California Regional Water Quality Control Board

**Subject Site: Hanson Aggregates, 9225 Camino Santa Fe, San Diego, CA 92121
(WDID No. 9 371014663)**

**RE: NOTICE OF VIOLATION NO. R9-2010-0060 &
REQUIRED TECHNICAL REPORT**

7. Sediment has accumulated on the stream side of the rock berm.

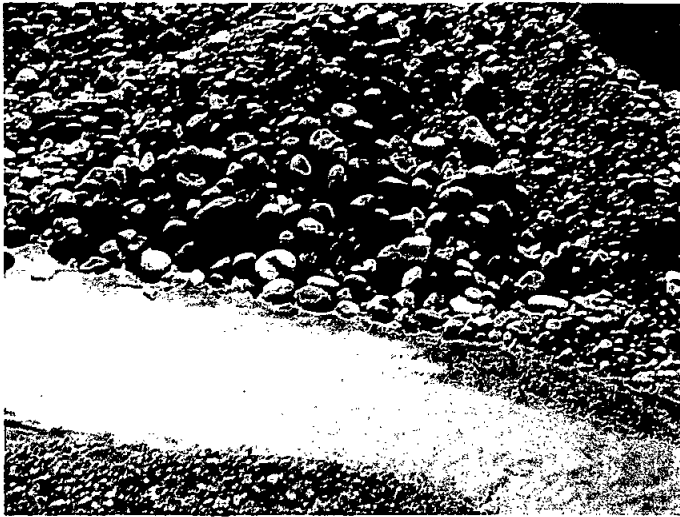
8. Sediment has accumulated on the road. This sediment should be removed since it may be washed into the creek during a subsequent storm event.
